Review #1:

Reviewer #2:

In this manuscript, the authors analyze a multi-year time series of shallow groundwater levels in 15 wells and stage at 5 stream locations in two catchments. They identified events throughout the study period and compared groundwater responses to stream response in several ways to determine how often hillslopes connected to the streams, whether or not connectivity depended on underlying geology, and if monitoring wells at a footslope can be informative of catchment connectivity. In their conclusions they describe how the mechanisms by which footslopes connect to the stream are likely different between the two geologies in the study (fill and spill vs. transmissivity feedback), while the frequency of connection didn't vary significantly. Furthermore they conclude that a single well in a footslope in a catchment can describe catchment connectivity, and that many years of data are required to adequately describe the processes they investigated.

Figure 1. The Attert catchment in western Luxembourg and the five monitoring sites: M_D, M_J, M_K (marls), S_J and S_V (schist). Top left: catchment topography, top right: geology, bottom: the five subcatchments including land use.

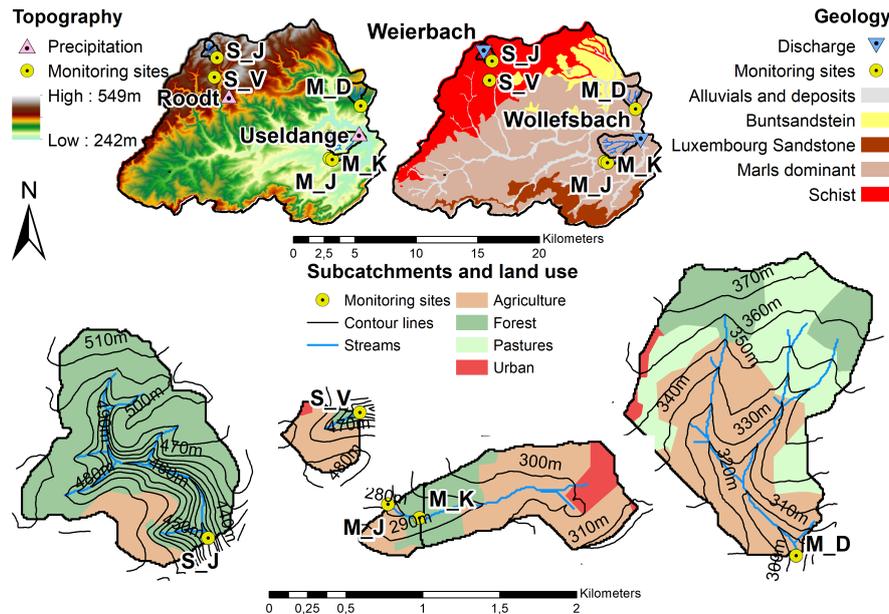
Figure 1: I know there is a lot going on in this figure already, but some indication of land cover could be good

Information about land use was added to the Figure but only for each subcatchment as it would have been too cramped otherwise (page 4, Figure 1).

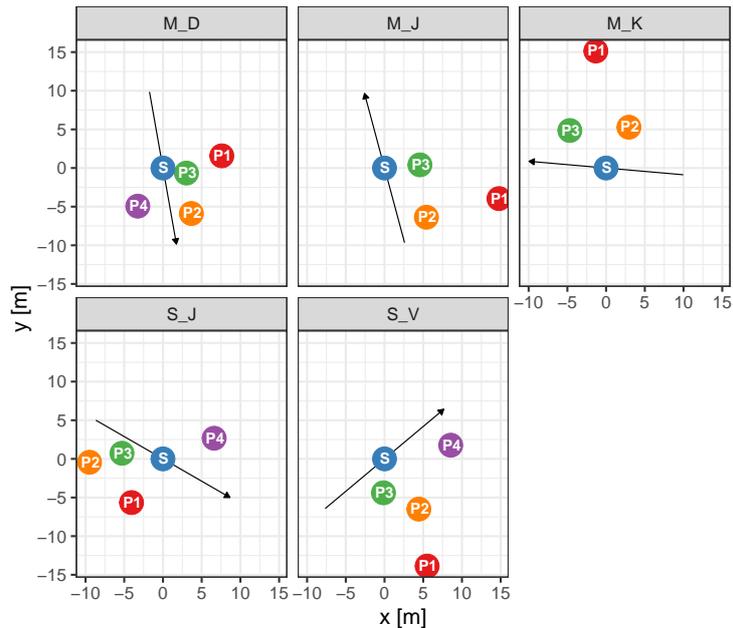
Figure 2: and all figures: since the bedrock comparison is important for the study, it could be good to indicate that more clearly in these figures, so maybe a different colour in the tabs where the site labels are for the two bedrock types, or just labelling them with the name of the bedrock types... just a suggestion.

Figure 3. Elevations of ground level (upper end end of the bar) and sensor level (lower end) relative to the stream bed. Stream sensors were installed slightly below the stream bed (negative lower end). Distance to the stream is shown on the x-axis. Colour coding is the same as in Figure 2.

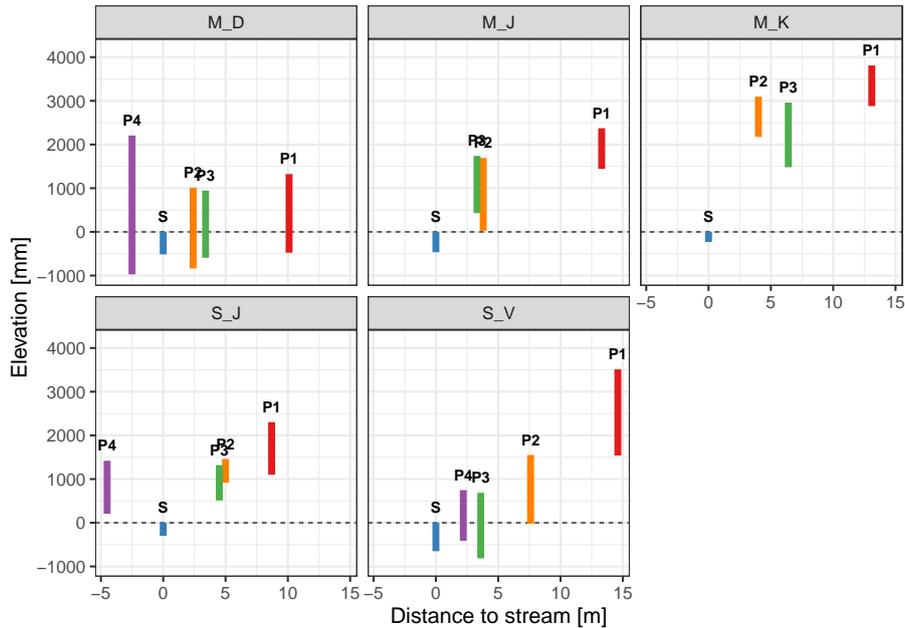
- Figure 3: Please mention in the caption the meaning for the different length of the stream bar in each site.

A sentence for the stream sensors was added. (page 6, Figure 3)

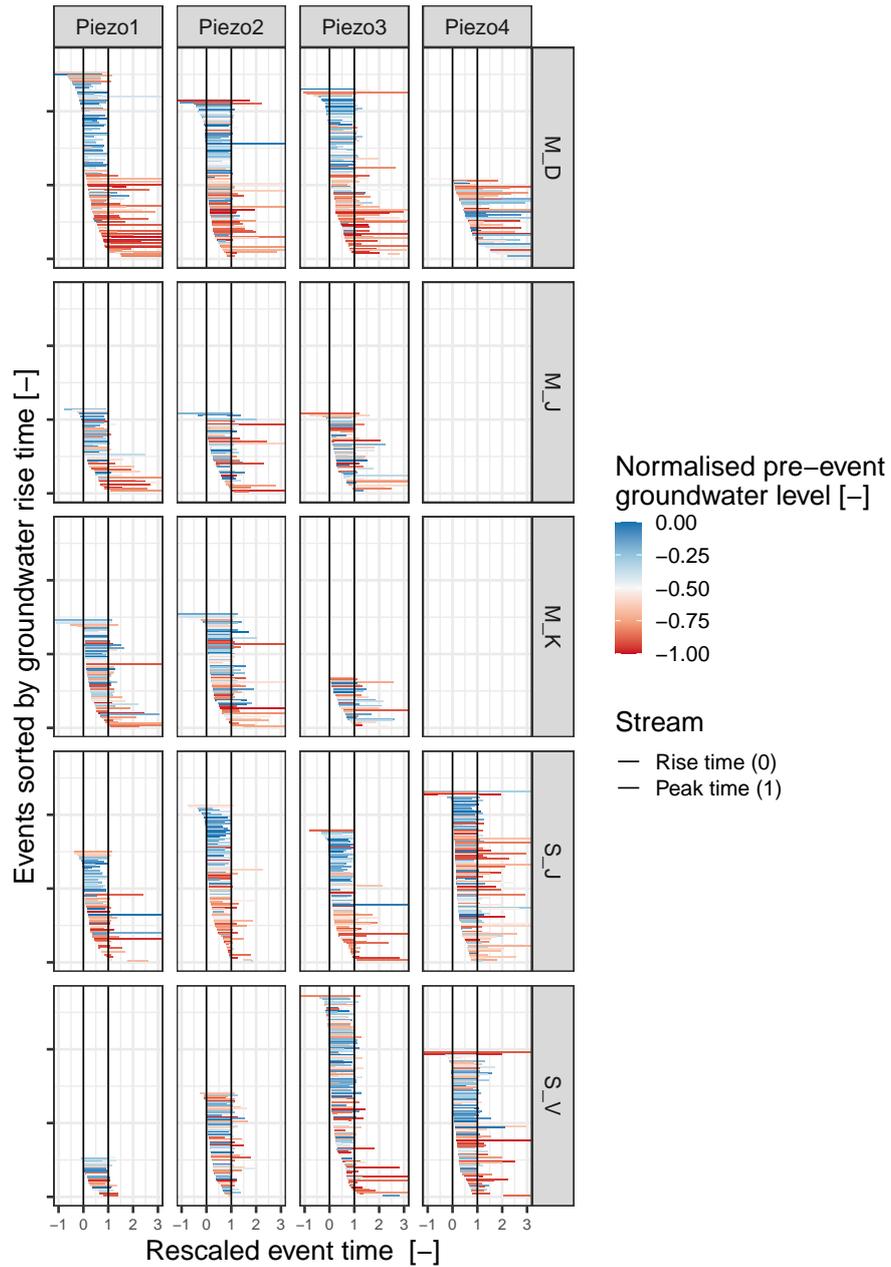
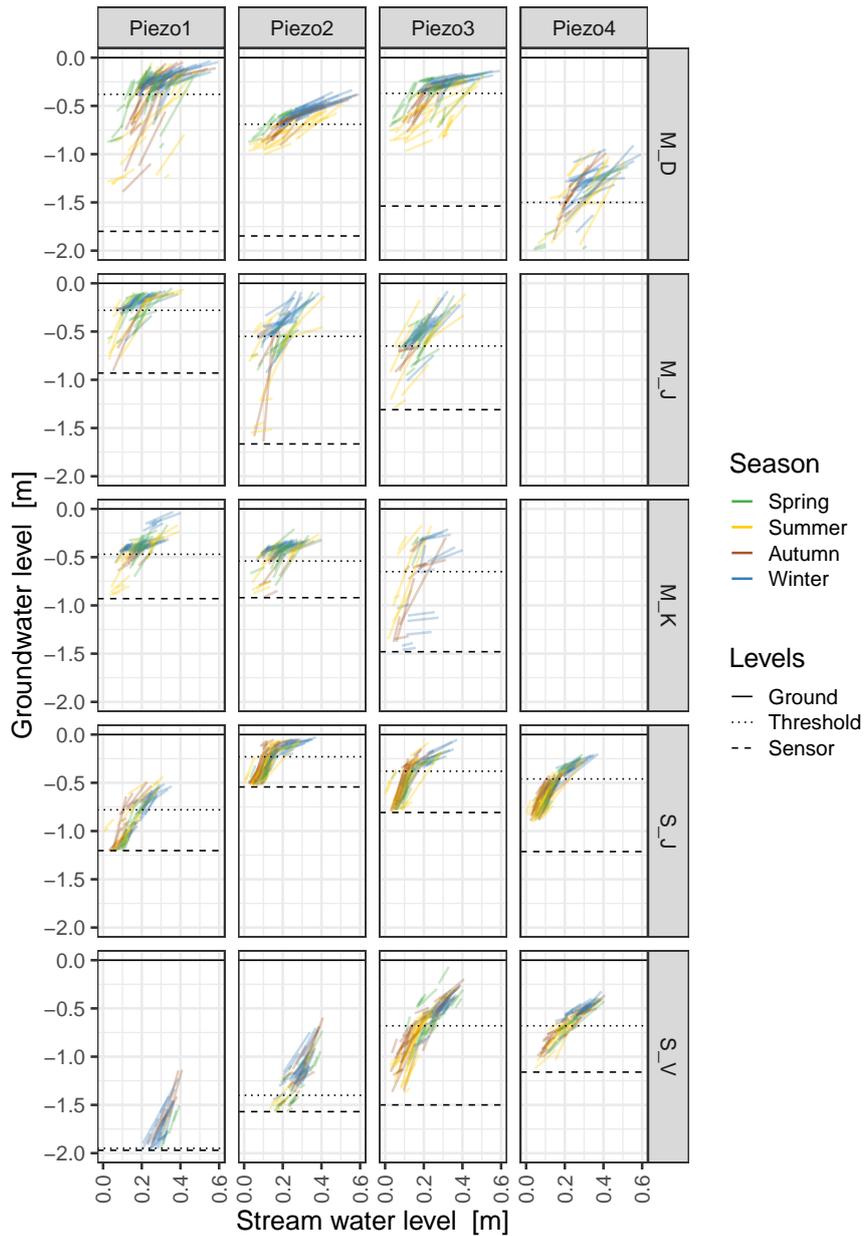
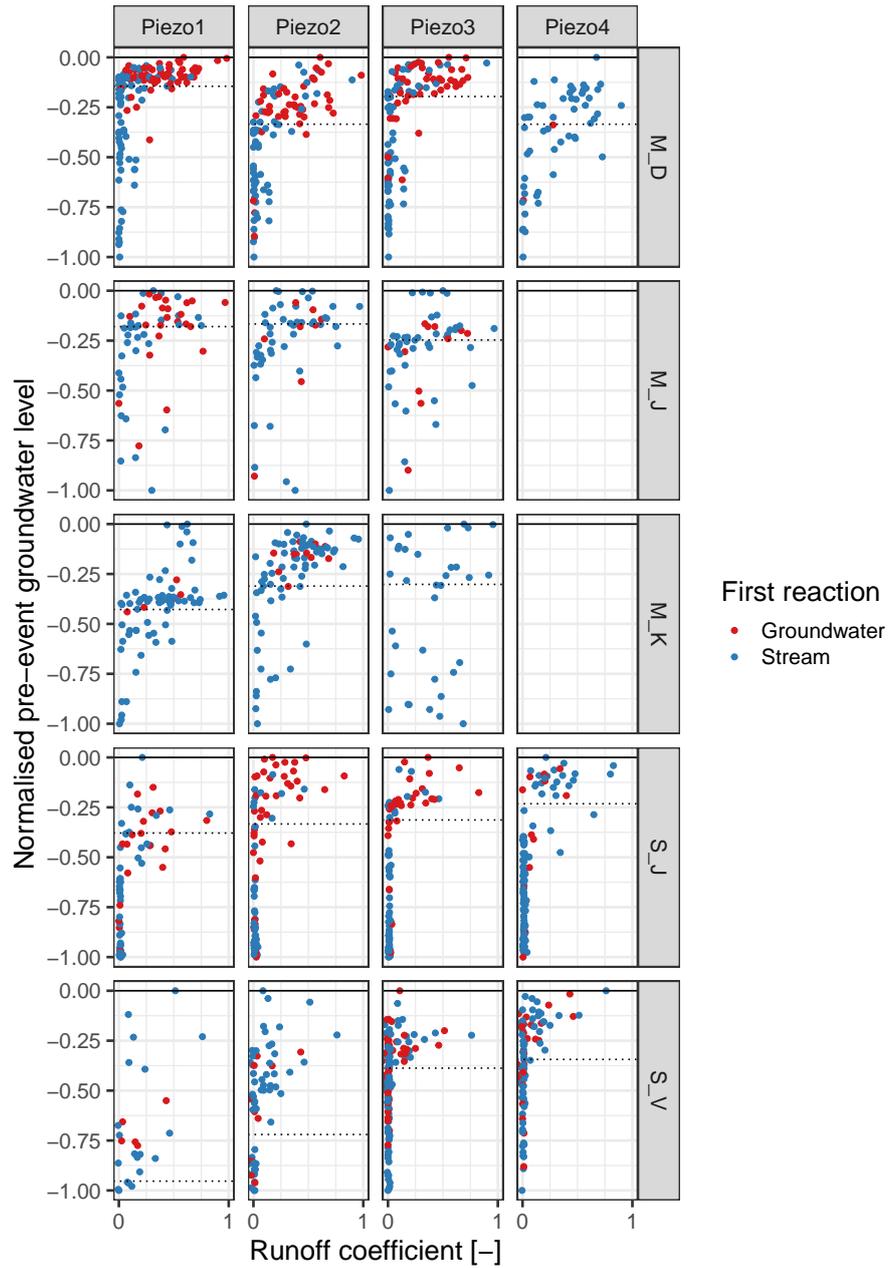
Figure 9: For this and figures 10 and 11: I wonder if there is a way to indicate in these, without them getting too cluttered, how far the wells are from the stream. While they are all considered “near stream”, some are much further away than others, and seeing that information might aid in interpretation

We tried to add distance-to-stream to these three plots but unfortunately could not come up

with a solution that supports the visualisation of the data. As Figure 3 shows the distance and gives an overview on the topography, it might be more helpful to use this as an auxiliary information when interpreting the results rather than adding more information into the plots.

Appendix B: Visualization of information loss when monitoring only one year instead of multiple years

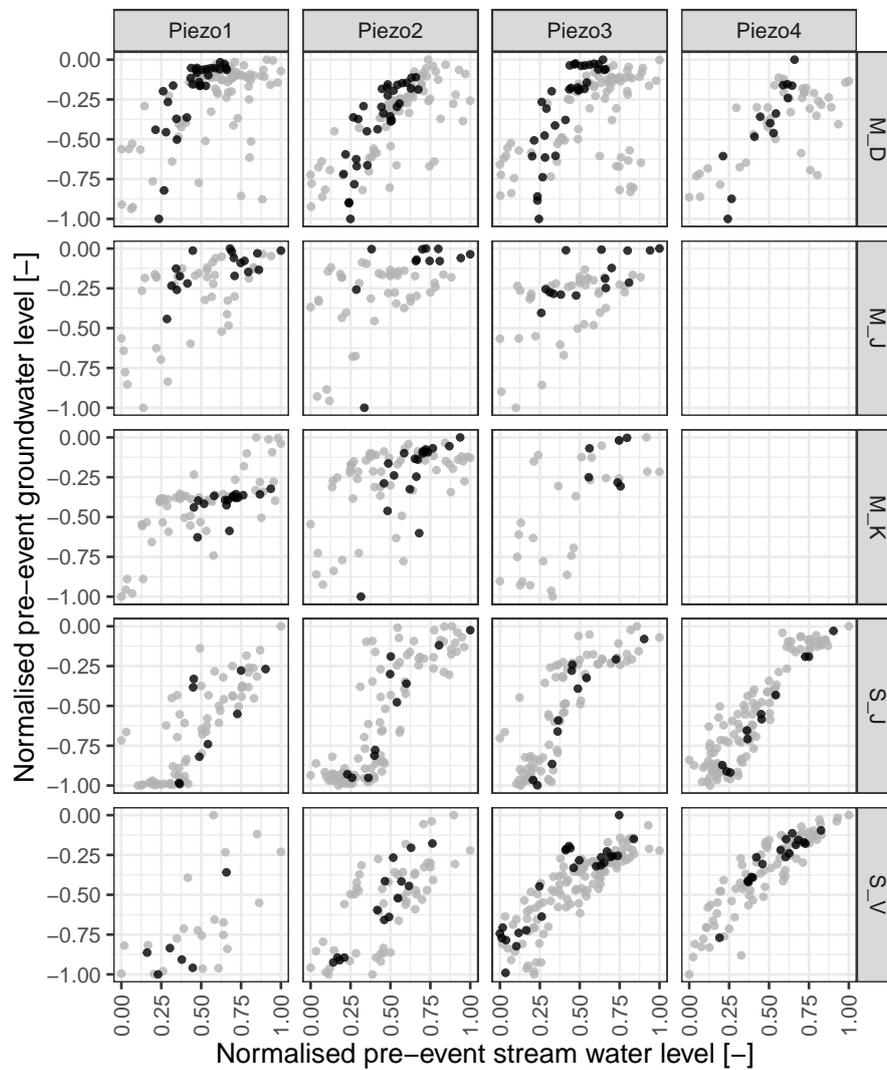
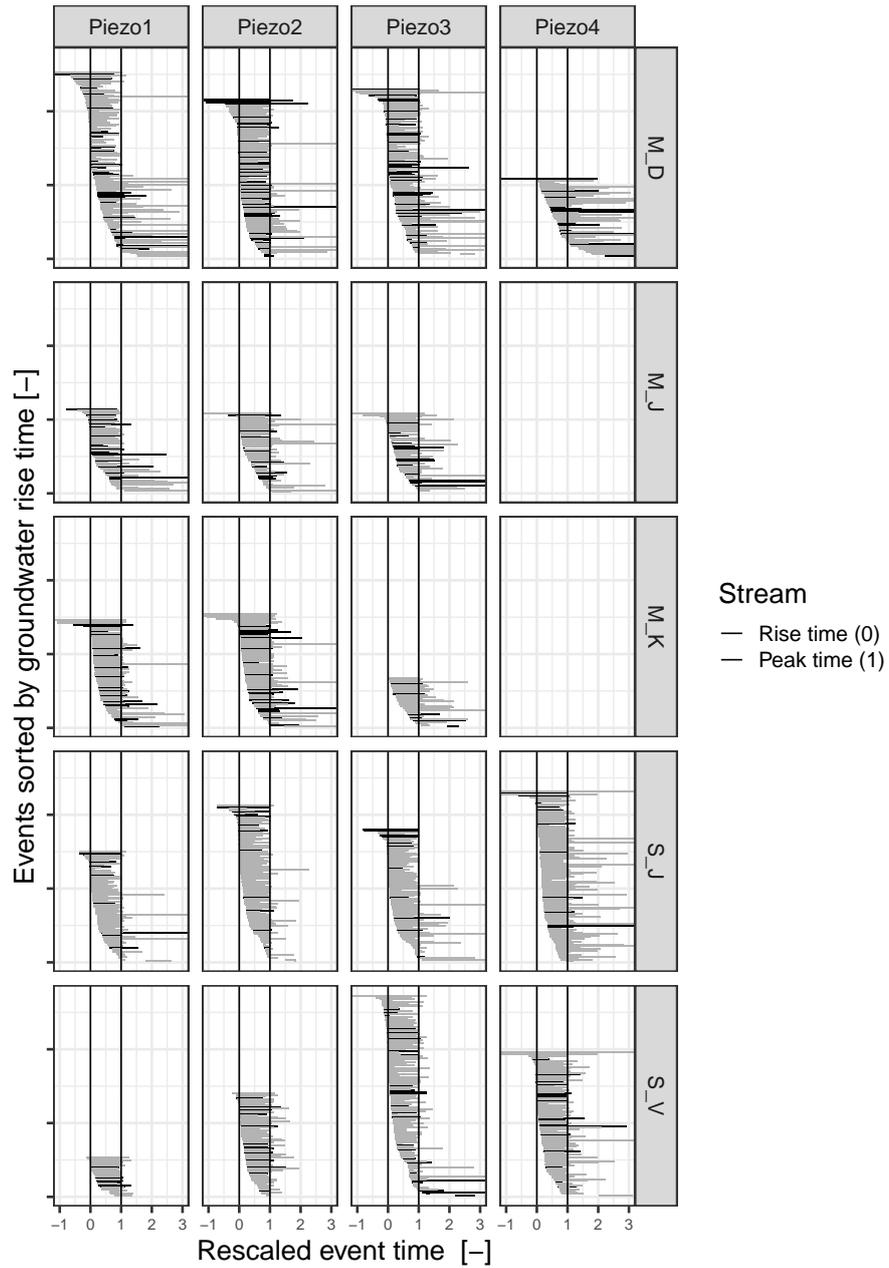
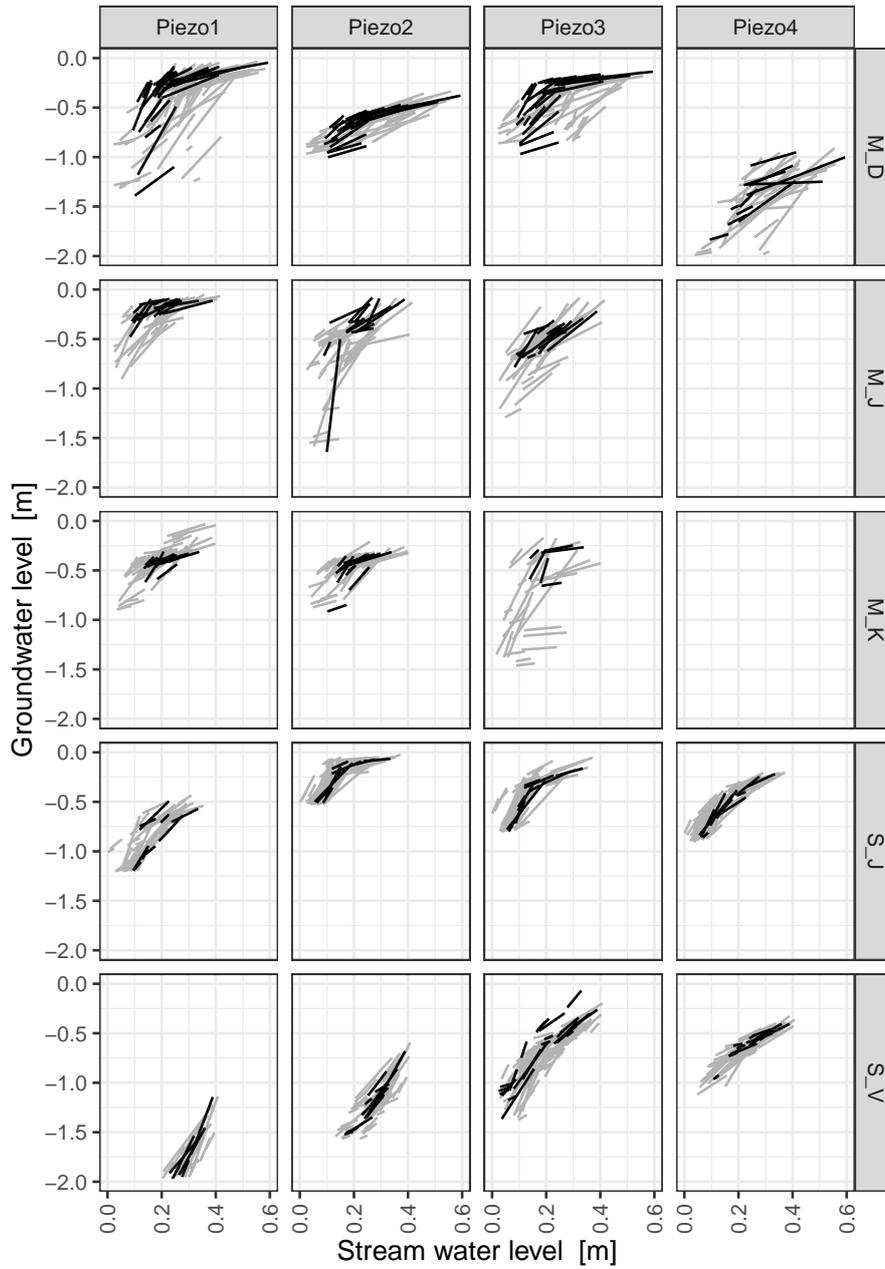
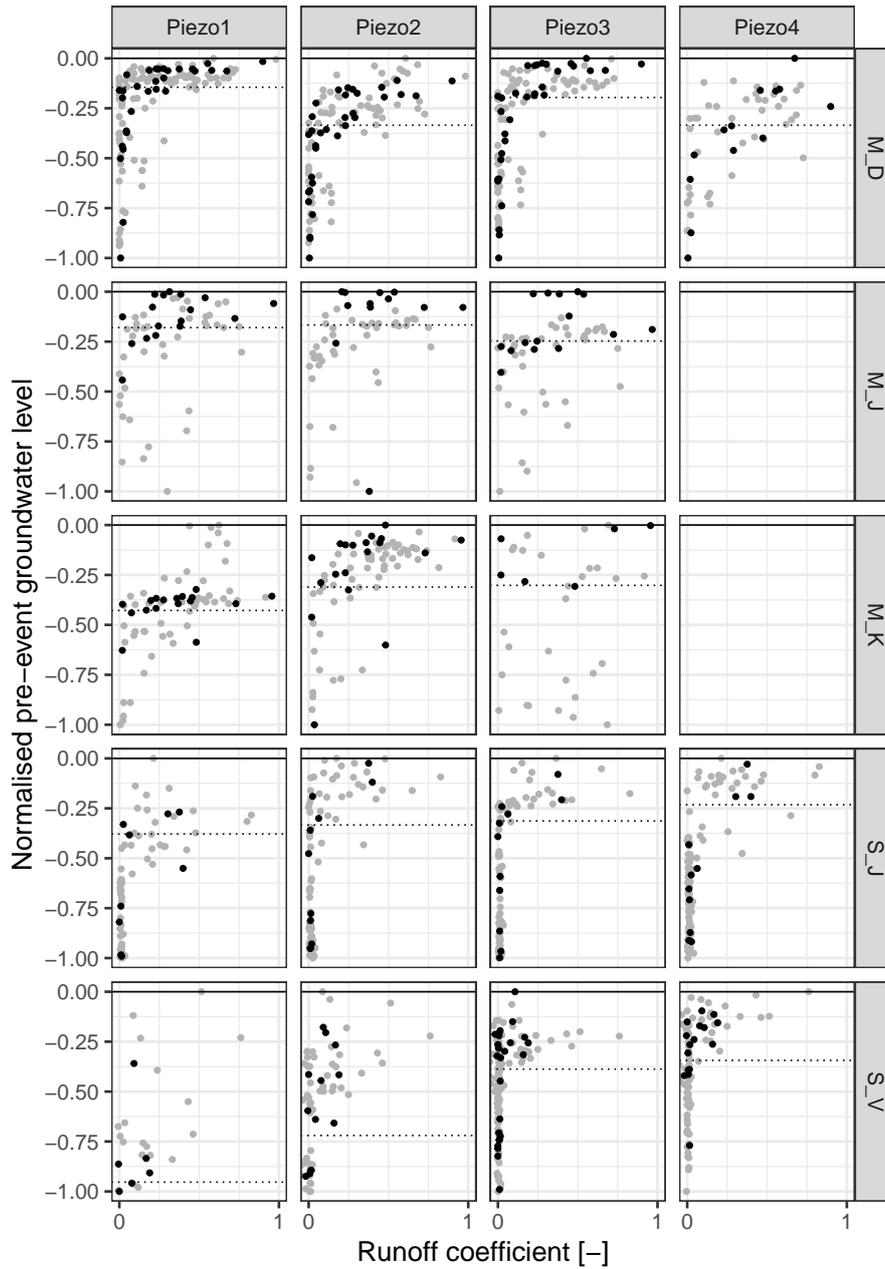
The first finding that I think needs work is that this study illustrates that you need many years of data to make the conclusions made in the study. I certainly don't disagree! I think this is probably true. However, I don't see in the paper where this is demonstrated quantitatively. I think the authors would need to show how the conclusions would differ if you showed only one year, compared to the entire time series. This might be accomplished by a version of figure 8, 9, or 10 that highlights one year of the data and how that differs from the total time period of the study. However, I wonder if the authors need to make this conclusion. I think there are plenty of other conclusions in the paper without having to make this one, which might necessitate more figures and analysis in an already figure-heavy paper.

We appreciate the point being made here. Since we consider the coverage of multiple years as very important, we suggest adding a few figures (see below) to the appendix to exemplarily highlight what difference it would make if we had monitored one particular year (2015 in this case). Instead of going into detail for each variable, site and piezometer, this serves to visualise what information is missing, leading to misinterpretations such as linearity where there is none,

To clarify this point we have added additional figures to the appendix (see above).
